Re: Docket #5 & 6, BAR #2021-00654 & 2021-00655, Old and Historic Alexandria District, January 5, 2022

We are writing to you to request a deferral and restudy of the request for demolition and a certificate of appropriateness for the proposed project at 322 S. Lee Street. As set forth in detail below, we do not believe that the public has been provided with sufficient information to evaluate and comment on the proposed project and are concerned that the current COVID emergency has and continues to hamper the normal processes of review of the construction approval applications before the Board.

Russell Jones, Photographer

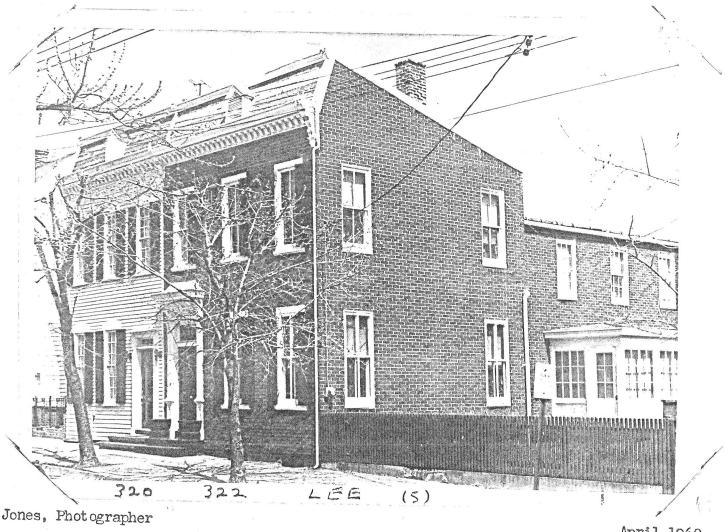
Again, the Staff Report has not addressed whether there is historic fabric here and whether it can be repaired. There is no analysis at all as to the age of each of the windows. The 1960 Russell Jones photograph in the Cox collection at the Alexandria Public Library (Attached) shows that 6/6 windows are on the 2nd floor of the ell. Therefore, there is a strong likelihood that some of the windows and certainly their placement is historic.
